## ***Interactive comment on “The yearly amount and characteristics of deep-buried phreatic evaporation in hyper-arid areas” by H. Li et al.***

Note Response to Anonymous Referee #1

Hydrol. Earth Syst. Sci. Discuss., 12, C6197–C6200, 2016 www.hydrol-earth-syst-sci-discuss.net/12/C6197/2016/ © Author(s) 2016. This work is distributed under the Creative Commons Attribute 3.0 License. Interactive comment on “The yearly amount and characteristics of deep-buried phreatic evaporation in hyper-arid areas” by H. Li et al. Anonymous Referee #1 Received and published: 18 January 2016

Fig. 4. Temperature and humidity at different soil depths in the greenhouse.

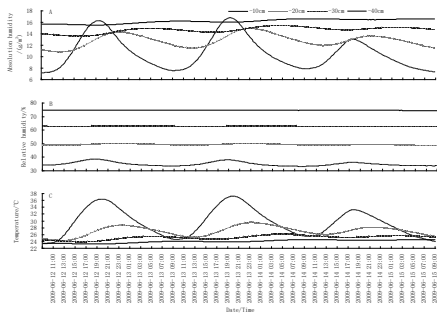
9. Section 4: the Discussion section should be rewritten according to the previous suggestions. At present, daily fluctuations of temperature and soil moisture are not shown; therefore it is difficult to follow discussions such as the one reported in Section 4.1. Similarly for Section 4.2, I am not able to see any connection between the data reported in Figure 3 and soil moisture hysteresis. Maybe the reviewer did not see our reference paper, Line 137-139: "Prior to this study, migration mechanisms were analyzed based mainly on the daily temperature and humidity of shallow soil at 0–60 cm (Li et al., 2010a; 2014a)", Li, H.S., Wang, W.F., Zhan, H.T, Qiu, F., and An. L.Z.: New Judgement on the source of soil water in extremely dry zone. *Acta Ecologica Sinica*, 30(1): 1–7, 2010a. Li, H.S., Wang, W.F., and Liu, B.L.: The daily evaporation characteristics of deeply buried phreatic water in an extremely arid region. *J. Hydrol.*, 514 (6):172–179, 2014a. In these paper, the daily water content variation was shown as Fig. 3, the daily temperature and humidity was shown as Fig. 4.

Here is Fig. 3 Here is Fig. 4

We cannot insert all the figures in this one paper. If you have read our related research paper (as in the reference), we think the discussion part is clearly. About soil-water hysteresis we explain as below, Ssoil water content very more important for phreatic evaporation, especially at 10 to 20 cm depth. There are soil-water hysteresis effects to consider, i.e. the water-related characteristic curves of drying soil (basal water content is low) are different from those of soil that is wetter (basal water content is higher), as shown in Fig. 5.
